Work Order ID 108433

Item Name: Aft Crosstube

**DART AEROSPACE LTD**  
HAWKESBURY, ONTARIO, CANADA  
DRAWING NO. D407-667-245  
TITLE CROSSTUBE ASS'Y (407 HIGH AFT)  
REV. F  
SHEET 1 OF 4  
SCALE NTS  
COPYRIGHT © 2002 BY DART AEROSPACE LTD  
THIS DOCUMENT IS PRIVATE AND CONFIDENTIAL AND IS SUPPLIED ON THE EXPRESS CONDITION THAT IT IS  
NOT TO BE USED FOR ANY PURPOSE OR COPIED OR COMMUNICATED TO ANY OTHER PERSON WITHOUT  
WRITTEN PERMISSION FROM DART AEROSPACE LTD.

DRAWING NO. D407-667-245		TITLE CROSSTUBE ASSY (407 HIGH AFT)		REV. F		DART AEROSPACE LTD ENGINEERING ORDER		D.E.O. NO. D407-667-245-F-1		SHEET NO. SHEET 1 OF 2		SCALE NTS	
DRAWN		CHECKED		MFG. APPR.		APPROVED		DE APPR.		DATE		DATE	
11.04.08		11.04.12		11.04.12		11.04.12		11.04.12		11.04.12		11.04.12

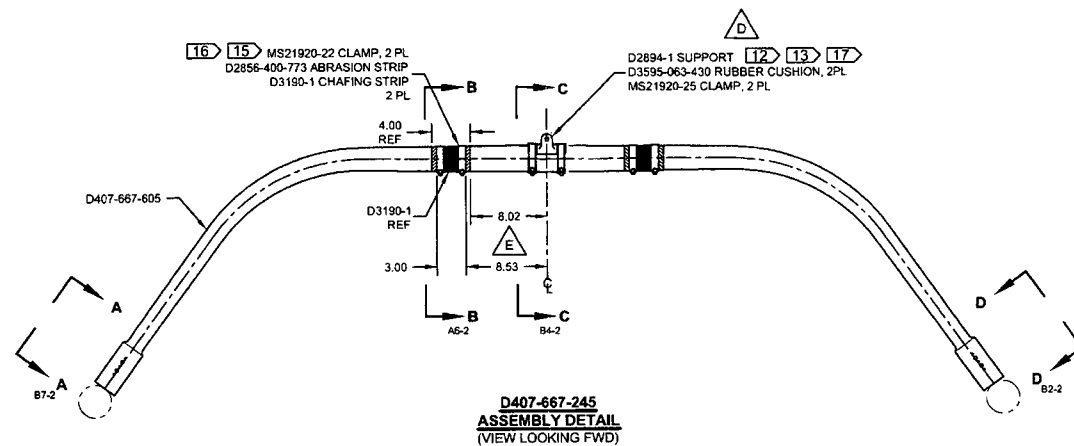
F	REFORMAT NOTES TO NEW STANDARDS (ZN B8-1); RELOCATED FLAG # 6 (ZN A8-3) PER NCR 210; REMOVED REF. & ADD TOLERANCES (ZN C6-3, C4-3 & D2-3)	RF	08.11.05
E	8.02 AND 8.53 WERE 8.40 AND 8.90 (ZN D5-2); REORGANIZED VIEWS AND REFORMATED DRAWING TO CURRENT STANDARDS. REASONS: CLAMPS MOVED 0.375 TOWARD CL TO ELIMINATE INTERFERENCE WITH AIRCRAFT MOUNTS. REFERENCE: FAR#08-21 AND ECH#1225	MB	08.07.24
D	ADD VIEW FOR OEM SKID HOLES. ROTATE ORIENTATION OF CLAMPS SECTION F-F. REMOVE -851 ABRASION STRIP, ADD MAGNOBOND 6398, ADD CUSHION	PH	07.02.07
C	ADD HOLES AND NUT PLATES FOR COMPATIBILITY WITH BHT/AA SKIDTUBES	PH	05.07.26
B	ADD CHAFING SHIELD	CP	03.05.21
A	NEW ISSUE	CP	02.05.13
REV.	DESCRIPTION	BY	DATE
DESIGN	9P		
DRAWN	RF		
CHECKED	9P		
MFG. APPR.	9P		
APPROVED	9P		
DE APPR.	9P		
DATE	08.11.06

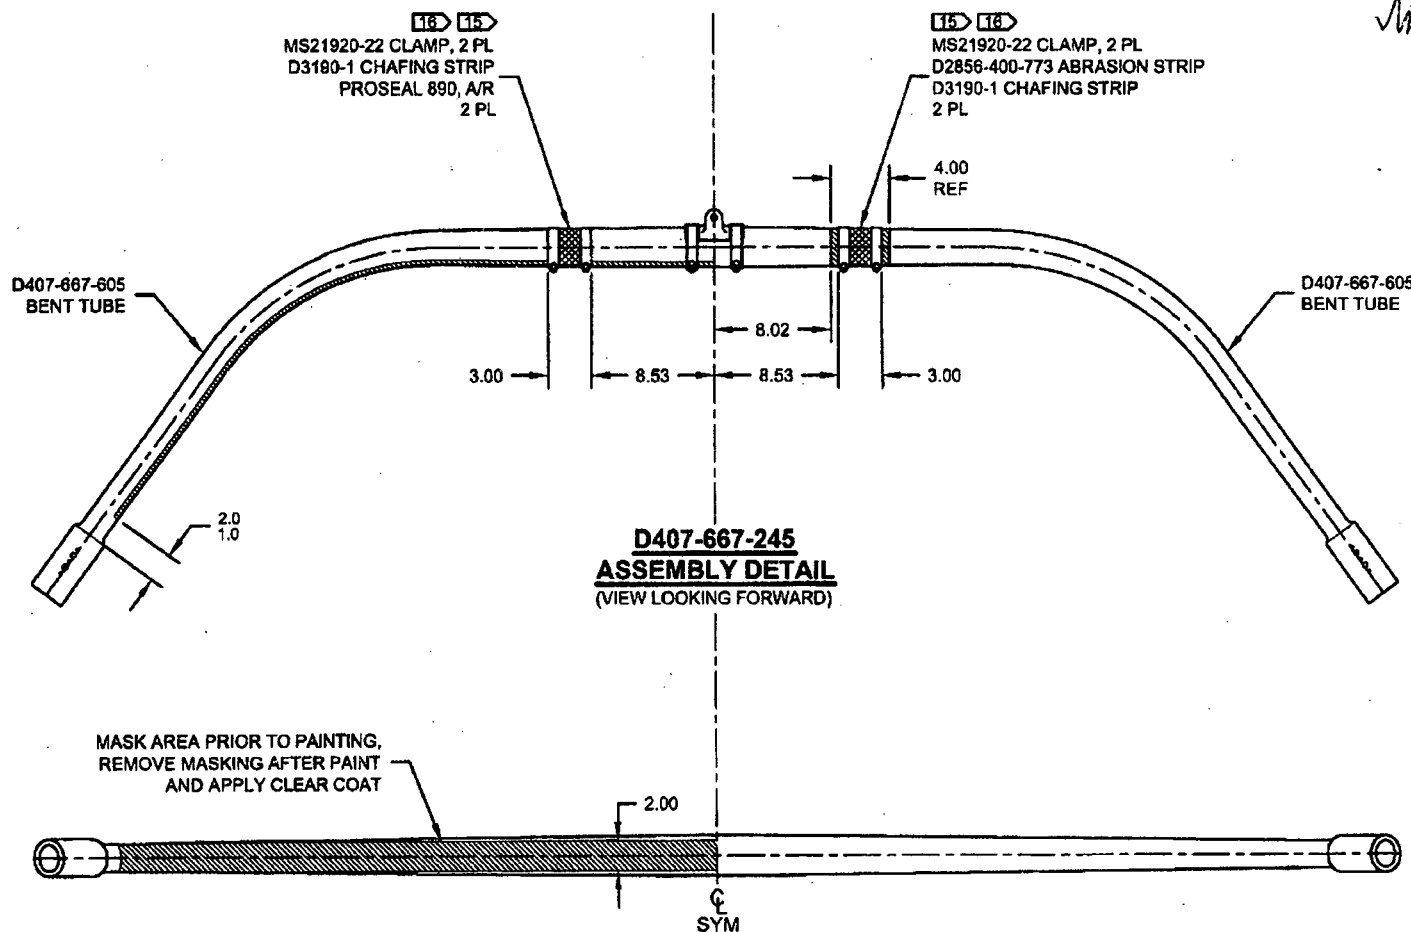
**CHANGE:**

NOTES 2 AND 15, SHEET 1 ARE AMENDED AS FOLLOWS:

- 2) FINISH: CHEMICAL CONVERSION COAT PER DART QSI 005 4.1  
PRIME INSIDE AND OUTSIDE PER DART QSI 005 4.2  
MASK UNDERSIDE OF CROSSTUBE AS SHOWN (HATCHED AREA) AND  
PAINT OUTSIDE PER DART QSI 005 4.2  
REMOVE MASKING AND APPLY CLEAR COAT
- 15) APPLY A THIN COAT OF PROSEAL 890 ON INSIDE CONCAVE SURFACE OF D3190-1  
CHAFING SHIELDS AND LET CURE PER MANUFACTURER'S INSTRUCTIONS. INSTALL  
PROSEALED D3190-1 CHAFING SHIELDS ONTO CROSSTUBE BY APPLYING A THIN COAT  
OF PROSEAL 890 ONTO CROSSTUBE. BE SURE TO ELIMINATE ANY AIR GAPS.

- 2) FINISH: CHEMICAL CONVERSION COAT PER DART QSI 005 4.1  
PRIME INSIDE AND OUTSIDE PER DART QSI 005 4.2  
PAINT OUTSIDE PER DART QSI 005 4.2
- 15) INSTALL D2856-400-773 ABRASION STRIP WITH A 0.13 REF GAP ON BOTTOM SIDE OF  
CROSSTUBE PER QSI 035.
